# Access Compliance Report

### (Curb Ramps)

Intersection ID: 10025384	Main Street: E_9TH_ST	Cross Street: N/A	Location: S
ADA ID: ACEA553D261B	Ramp Type: PerpDiag	Initial Pass/Fail: Fail	Overall Compliance: No
Severity Score: 13.75			
Codes/Mitigation Info/Possible Solution		Field Measurements/Component Compliance

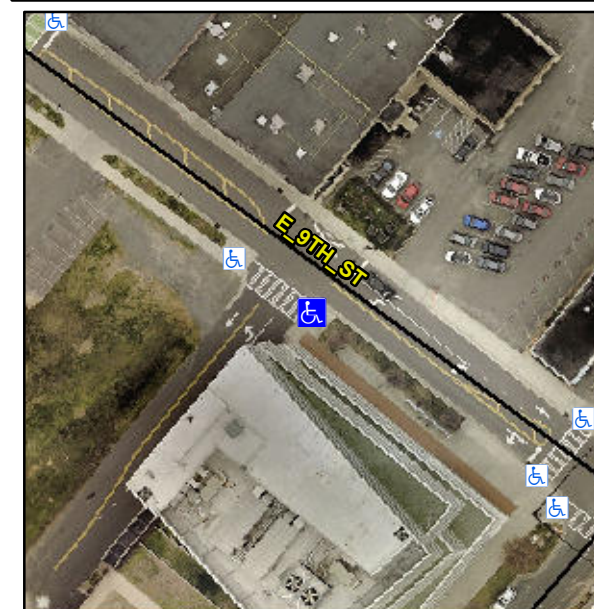
**R304.2.2, R304.5.3**

Compliance	Description	Data	Compliance	Description	Data
N/A	Ramp Length (in)	59.0	No	Ramp Slope (%)	9.1
Yes	Ramp Width (in)	48.0	No	Ramp XSlope (%)	3.0
N/A	Flare Type LT	N/A	N/A	Flare Type RT	N/A
N/A	Flare Slope LT (%)	N/A	N/A	Flare Slope RT (%)	N/A
N/A	Flare Traversable LT?	N/A	N/A	Flare Traversable RT?	N/A
N/A	Landing Length (in)	N/A	N/A	DWS Provided?	N/A
N/A	Landing Width (in)	N/A	N/A	DWS Contrast?	N/A
N/A	Landing Slope (%)	N/A	N/A	DWS Length (in)	N/A
N/A	Landing X Slope (%)	N/A	N/A	DWS Full Width?	N/A
N/A	Landing Curb? (Y/N)	N/A	N/A	DWS Offset (in)	N/A
N/A	Shared Landing?	N/A			
N/A	Gutter Ponding?	N/A	N/A	Gutter Slope (%)	N/A
N/A	Gutter Lip Ht (in)	N/A	N/A	Gutter X Slope (%)	N/A
N/A	Painted X Walk1?	No	N/A	Painted X Walk2?	Yes
	X Walk 1 Direction	To NE		X Walk 2 Direction	To NW
N/A	X Walk 1 Width (in)	N/A	N/A	X Walk 2 Width (in)	143.0
	X Walk 1 Slope (%)	1.6		X Walk 2 Slope (%)	6.3
	X Walk 1 X Slope (%)	1.6		X Walk 2 X Slope (%)	0.1

**Remove & Replace Curb Ramp With Two New Directional Ramps or Equivalent.**
